# Value Engineering Study Report

**KY 210 Widening Improvements – 4-80154.00**  
From Hodgenville to Campbellsville

*Larue, Green & Taylor Counties, Kentucky*

**Report Date: December 13, 2024**

## VE ALTERNATIVE IPO-1

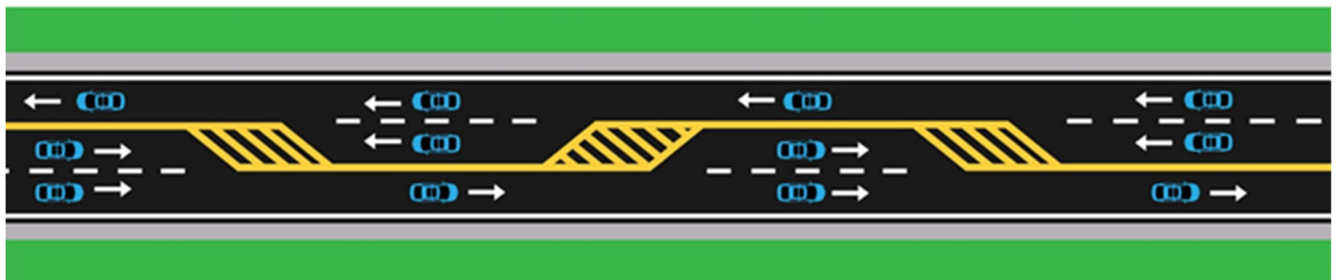
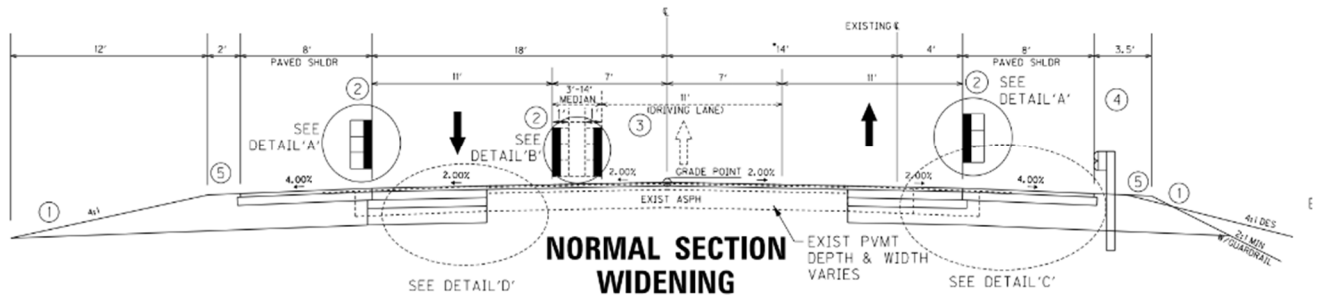
The baseline configuration is costly across all three sections as it requires roadway widening to accommodate the additional lane (resulting in 3 11' lanes) and shoulders (8' on each side). The main objective of this configuration is to provide alternating passing lanes in each direction. These passing lanes will provide improved operations and help reduce platooning and unsafe passing as is present on the 2-lane configuration.

The primary risk associated with this alternative is that it limits the extensiveness of the operational improvements present with the baseline concept.

### Provide Passing lanes at select locations in lieu of continuous 2+1 throughout

Alt No.	Alternative Title	Implement Status	Decision Rationale / Comments
<b>Improve Passing Opportunities</b>			
IPO-1	Provide passing lanes at select locations in lieu of continuous 2+1 throughout	Accept	The Project Development Team would like to accept this alternative and will try to incorporate passing lanes at select locations in lieu of a continuous 2+1 Roadway through out the project. Mr. Siwula discussion with D4 Team concerning positive data being collected on the safety benefits of the 4 foot flush medians when using 2+1 roadway types. There is potential to save money through providing passing lanes at select locations and still provide a 4 foot flush median. After further discussion at the end of the meeting the Project Team decided that it would greatly benefit the project to look at reducing the typical section for the entire project and not just for Section 2, they will look for natural passing zones to provide passing opportunities.

**VE ALTERNATIVE IPO-2**

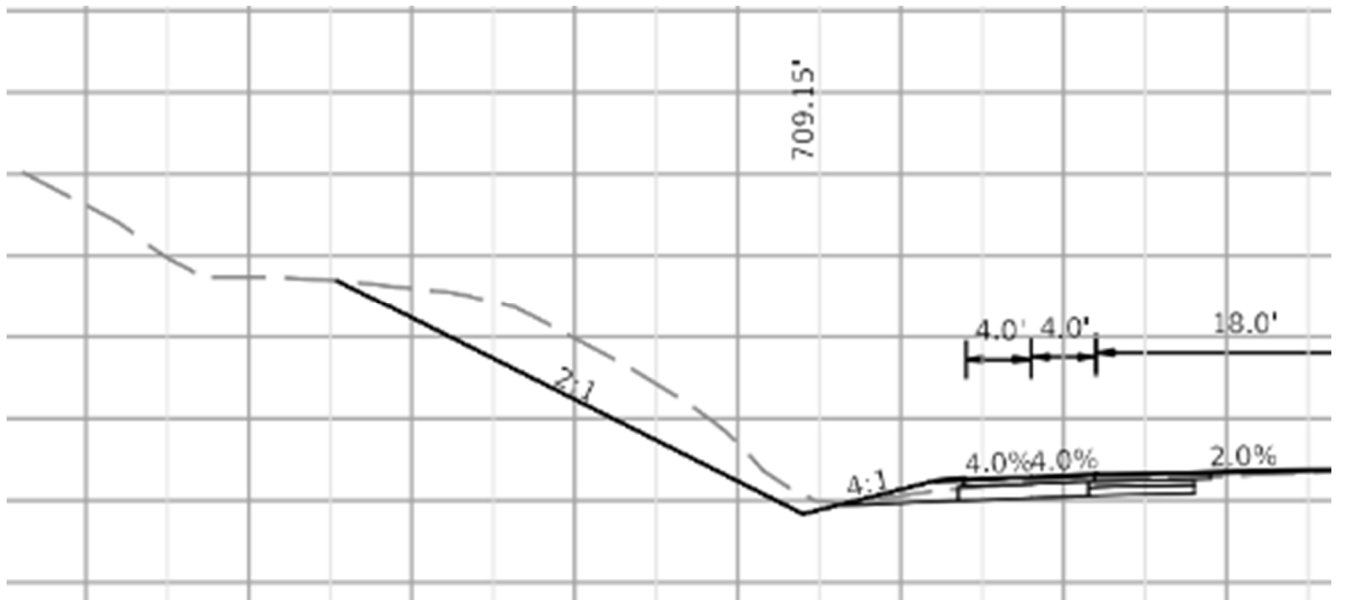
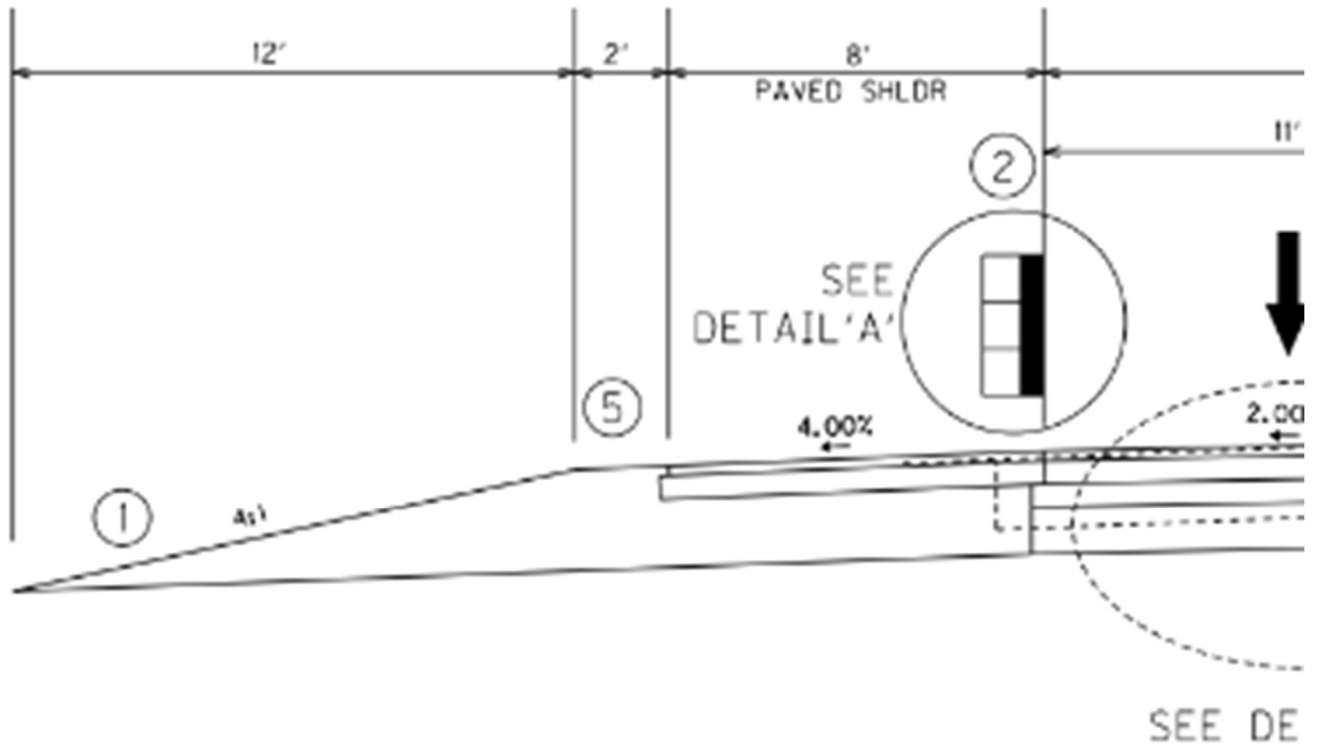
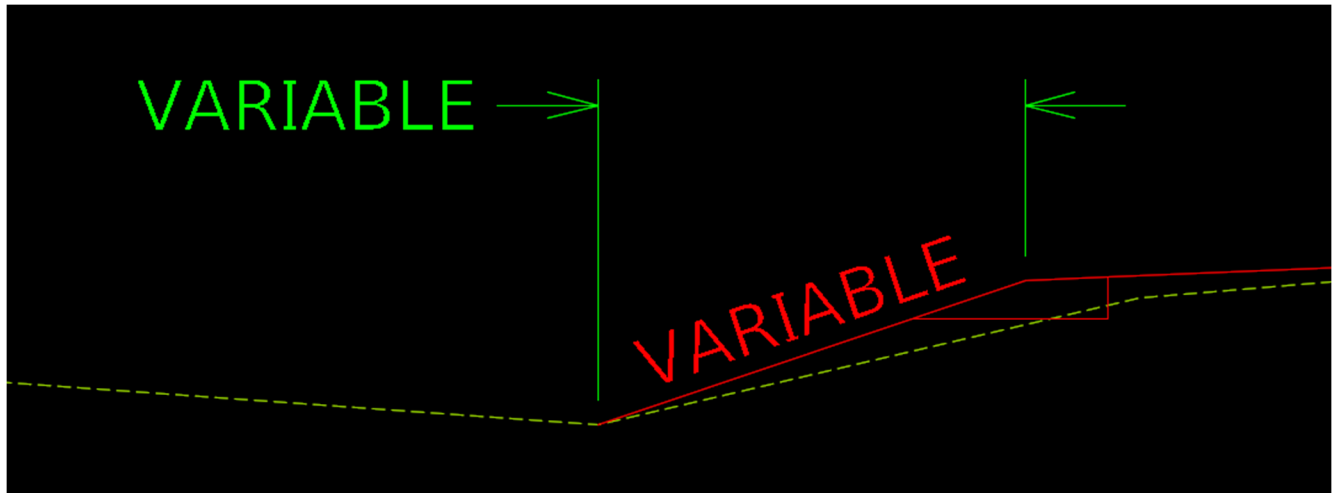
Utility impacts are a big risk on every project of this type. By keeping the roadway footprint narrow, the risk of impacting existing utilities are greatly reduced. The roadway remains within an existing disturbed area, so encountering rock or unknown materials is less likely, reducing the risk of a change order from the contractor. Some areas will have to be compared to crash history to make sure clear zone does not come into play in certain areas.

**Confine typical section to existing flowlines**

It is assumed that the fore slope will only be altered in areas that would result in adequate ditch depth and remove the “sliver” cuts from baseline. Cross sections are not available for Section 1, so assumptions have been made for the quantities that would be eliminated. As a standalone concept only evaluating the cross sections for earthwork, the savings are minimal. However, when considering the potential utility and Right of Way impacts once those are known, the alternative case could result in large savings.

IPO-2	Confine typical section to existing flowlines	Accept	The Project Development Team would like to accept this alternative to further plan development. The PDT will look at areas where can eliminate R/W impacts as much as possible. Some discussion made concerning any constructability issues, Eric and Johnathan felt that there should not be any constructability issues with this alternative. This alternative would be selective based on the side slopes, since would not want to compromise the maintainability of the slopes where guardrail would be required.

# VE ALTERNATIVE SI-1

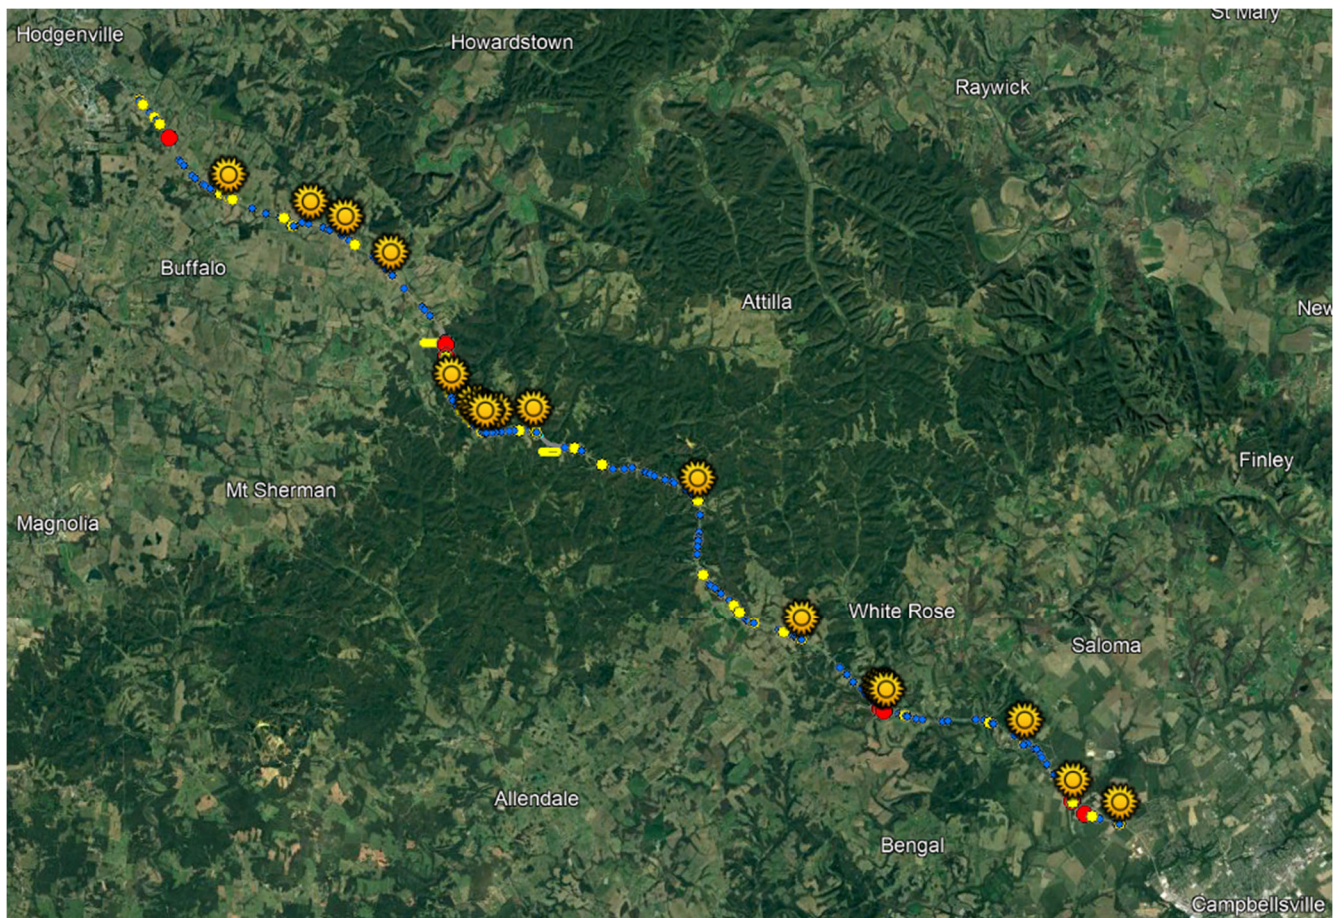
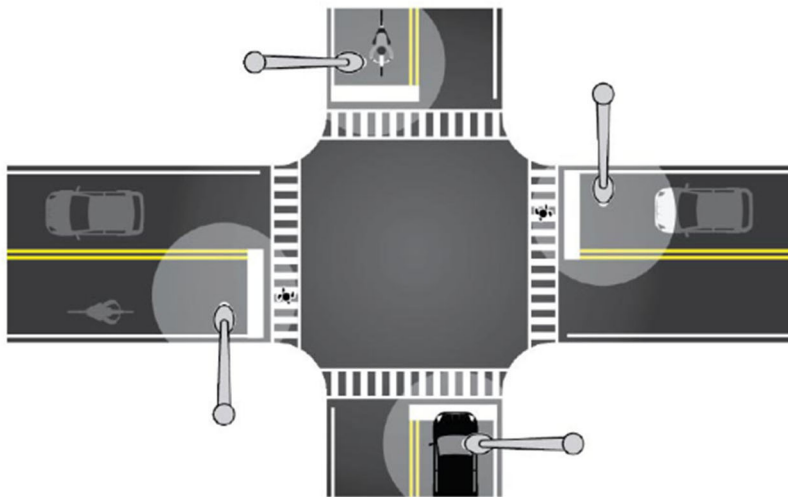
The safety analysis shows 38 nighttime crashes over the past 5-year period (detailed in the safety analysis summary). These crashes were distributed throughout the corridor and of various severities and crash types. While some of these crashes were animal collisions, which lighting may still have advantages in prevention). While the FHWA study and others show a reduction of up to 38% of crashes, it is likely not appropriate to assume the full benefit based on the baseline conditions. The baseline scenario will improve safety throughout the corridor with the 2+1 configuration as it will provide passing opportunities to eliminate the need for passing in the oncoming lanes.

Assuming the cost of a light pole (either solar or powered or combination) is \$10,000 (KTC research estimate of \$5,000-\$6,000 per pole, so it was increased to be conservative and account for increased cost for solar options) and the installation of approximately 25 lights along the corridor. The overall cost would result in \$288,000 added to the baseline concept.

However, if this added cost were compared against the crash cost savings, the benefit-cost ratio is 4.1-to-1 or a savings of approximately \$900,000. This is accounting for conservative estimate of benefits for the crash benefit and only accounting for 5-years of crashes for a 20- or 30-year project lifespan. The estimate of the number of lights and the locations is a preliminary estimate and will likely need to be adjusted and/or increased throughout the project to provide optimal conditions. Even so, if the lighting were to double or triple in number and/or cost it would still show significant benefit for crash cost savings.

## Install lighting at high-frequency crash locations

Alt No.	Alternative Title	Implement Status	Decision Rationale / Comments
<b>Spot Improvement Modifications</b>			
SI-1	Install lighting at select high-crash frequency locations. Consider solar / LED	Accept	The PDT would like to accept this alternative and consider lighting installation at select high-crash locations. District 4 has never included lighting on a project as a safety mechanism except for at interchanges and roundabouts. There was discussion of the possibility of using solar lights so the maintenance tasks are minimized. The District to work with the local municipality on this inclusion into the project.
SI-2	Revise Lincoln Parkway intersection with KY 210 with prioritized movements	Accept	The PDT would like to accept this alternative and look at designing a small roundabout (may not be a mini-roundabout) but would be as small as necessary at this location (potentially 120 to 130 ft diameter roundabout). There was some discussion concerning the KYTC Maintenance/Construction employees that use this intersection enroute to the maintenance barn and they indicated that it is often difficult to make a left turn at this location.

**VE ALTERNATIVE SI-2**  
**Revise Lincoln Parkway Intersection with KY 210**

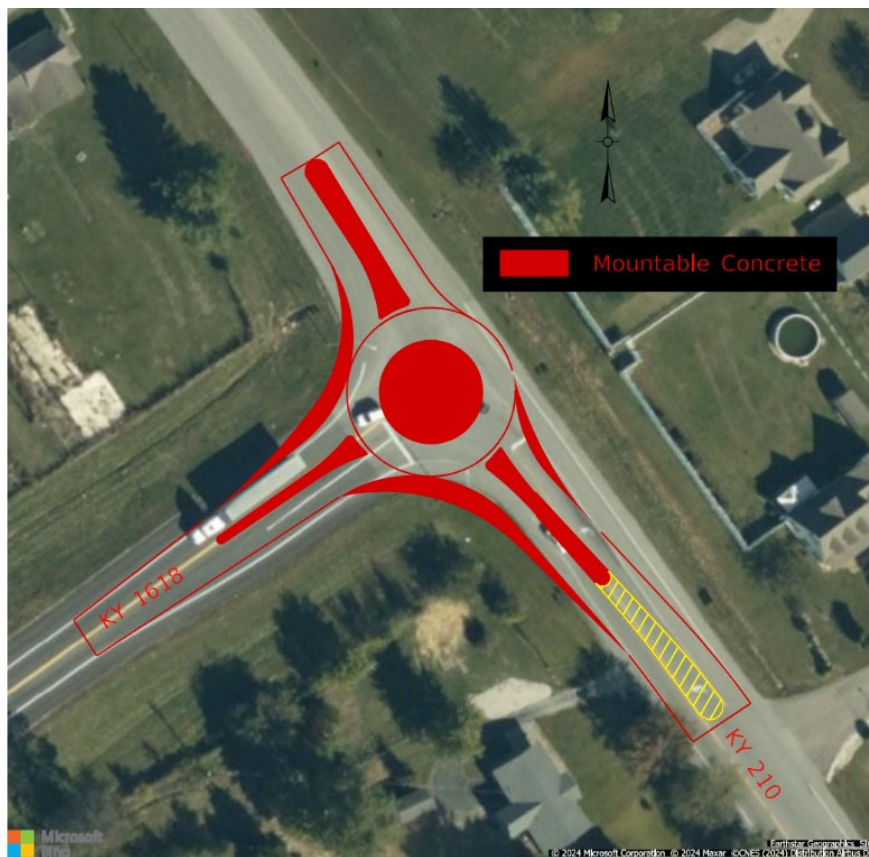
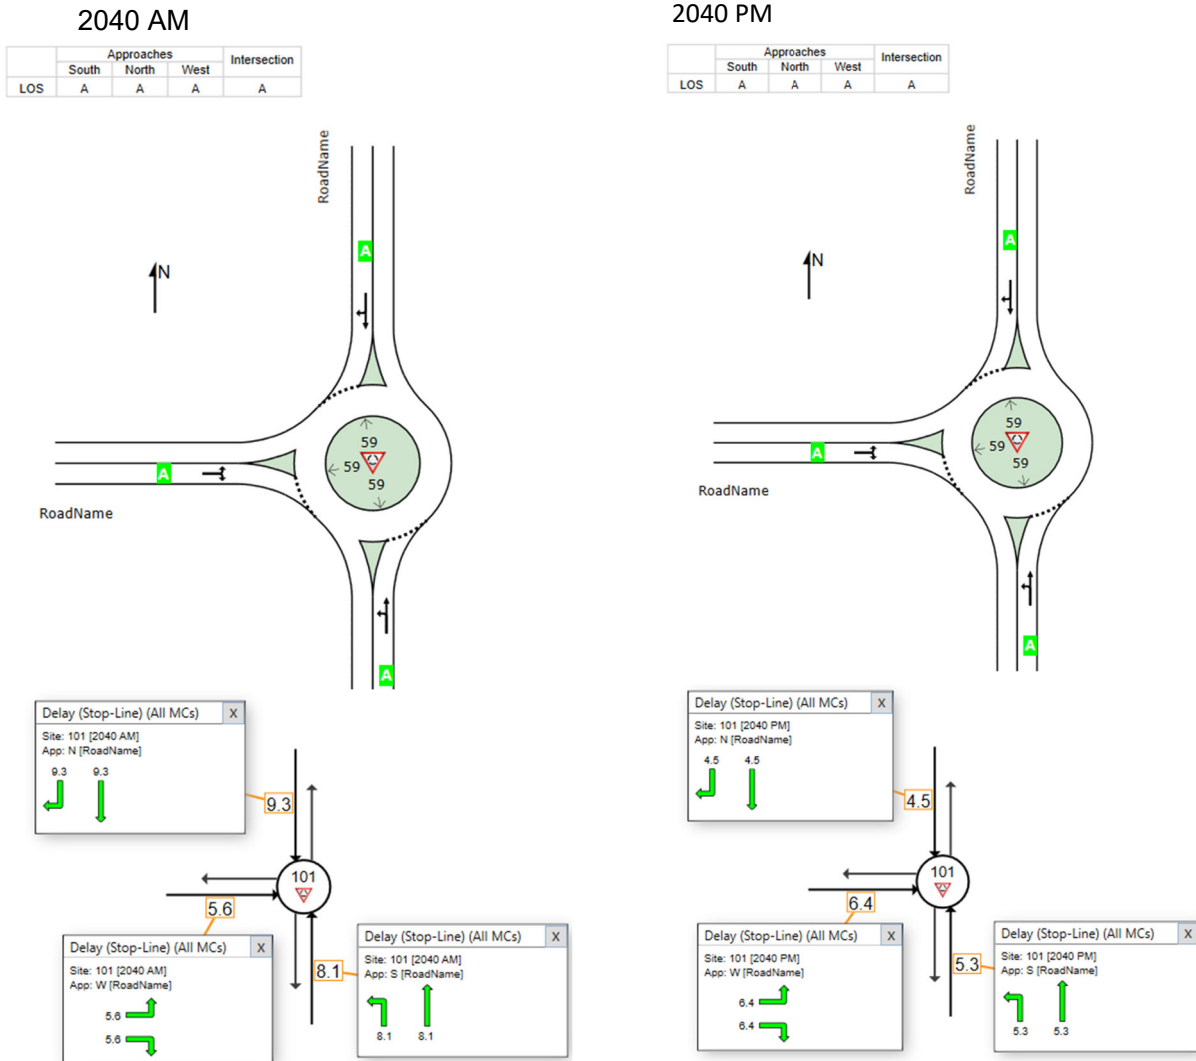
Operational Analysis Results:  
Using SIDRA 9.1 with HCM6 default parameters. 2040 AM and PM peak volumes. 10% trucks:

## VE ALTERNATIVE SI-3

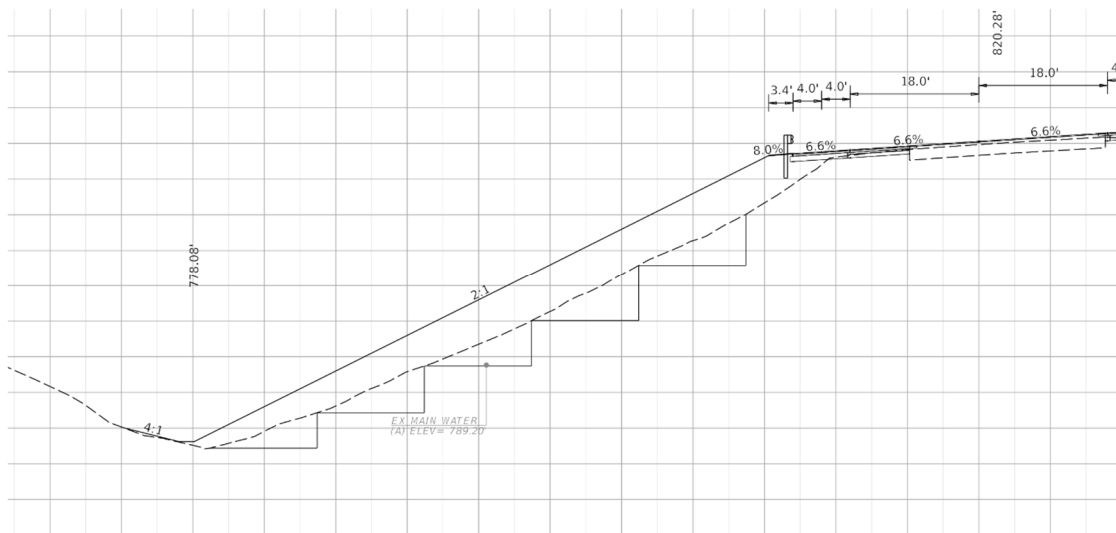
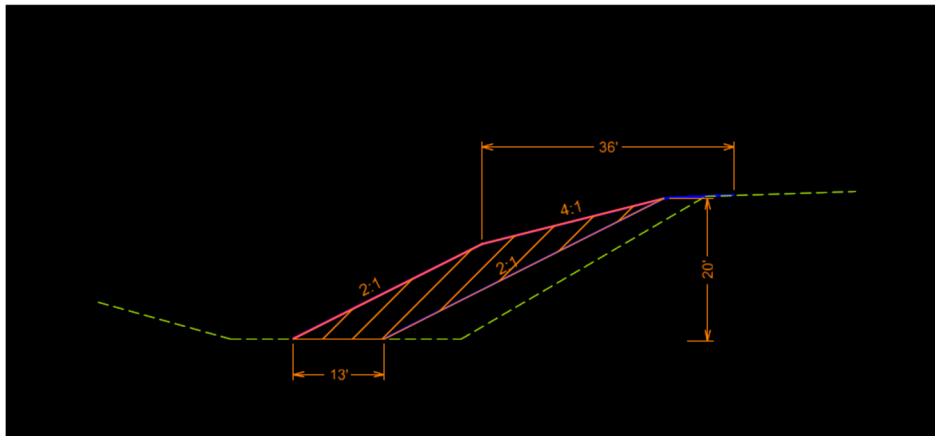
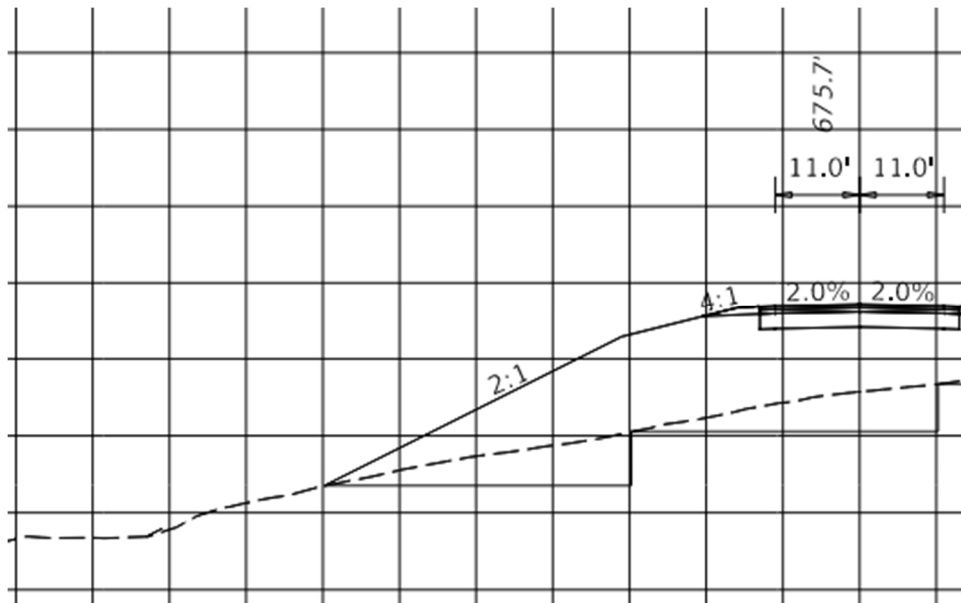
Balancing cut/fill is nearly impossible when widening an existing facility as the grade has mostly been set and is restricted due to various developments along the alignment. There are 147,918 cubic yards of excess material to be discarded by the contractor in Section 2 alone. Guardrail is a continuous maintenance issue as strikes occur. Using a "barn roof" typical section, a true 36' clear zone can be achieved by using a 4:1 slope outside the crushed stone base shoulder breakover. This means a driver has 36' beyond the edge of travel lane to correct their course prior to reaching a critical slope. Contractors are required to permit waste areas, and the less waste the contractor must haul off, the more economical the work can be performed. The balance will be much closer wasting material in the existing guardrail locations. Some additional Right of Way may be necessary over the baseline, but if project schedule/budget is at risk for the alternative, guardrail could always be implemented as originally designed. Culvert extensions will likely have to be extended farther than baseline to achieve the alternative slopes, so very large structures may not be as economical to extend. Long term maintenance of a 4:1 slope is much preferable versus guardrail against the edge of paved shoulder with a 2:1 slope on the other side.

### Use barn roof fill slope to limits of clear zone and eliminate guard rail

The additional area required for the “barn roof” typical section will need to be cleared environmentally, which increases the scope of work over using guardrail and tying down as soon as possible. More environmental clearance brings more risk into the project. There is also the risk involved with acquiring additional Right of Way.

SI-3	Use barn roof fill slope to limits of clear zone and eliminate guard rail	Accept	The PDT would like to accept this alternative and look at utilizing a barn roof fill slope to the limits of the clear zone to eliminate guardrail. The team noted that there could potentially be more maintenance on any 4:1 slopes for this option but would strategically consider the barn roof fill slope only at locations where that would not be an issue. There was some concern that Right of Way plans have already been completed for Section 2 and that any changes will have to be reviewed carefully. It was also noted that this project is leaning towards a waste project and could also potentially help with wasting material during construction. There was also some concern with the potential 4:1 slope to the clear zone distance and then becoming a 2:1 slope outside the clear zone and vehicles not being able to traverse the 2:1 slope.
